FIELD SERVICE CAMPAIGN – 19103

28 March 2019

Shift Lever

International® MV™ Series

Figure 1. Upper Shift Lever Assembly

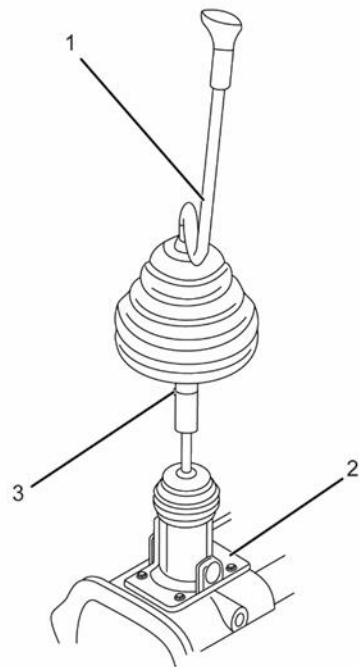
Upper shift lever may contact floor park brake shroud when in Reverse gear.

1. Shift lever
 2. Shift tower housing
 3. Set screw
-
4. Access transmission main tower assembly to remove upper shift lever and set screw (Figure 1, Items 1 and 3). Save set screw for reuse and discard upper shift lever.
 - a. Remove upper shift lever and set screw (Figure 1, Items 1 and 3). Remove and discard shifter boot.
 - b. Remove and discard shift tower housing (Figure 1, Item 2). Save shift tower housing bolts for reuse.

5. Remove and discard shift tower housing (Figure 1, Item 2). Save shift tower housing bolts for reuse:
 - a. If gasket is damaged, discard and replace with new gasket.
 - b. If gasket is undamaged, gasket can be reused.
6. Install new or undamaged gasket onto main case.
7. Position new shift tower assembly onto gasket and main case. Install shift tower cap bolts. Using torque wrench, tighten screws to 20 - 25 lb-ft (27 - 34 N·m).
8. Install upper shift lever and set screw. Tighten set screw securely. Ensure shifter boot is correctly seated.
9. Shift vehicle into Reverse. Make sure shift lever does not make contact with park brake shroud.
10. Shift transmission back into Park or Neutral.
11. Remove wheel chocks
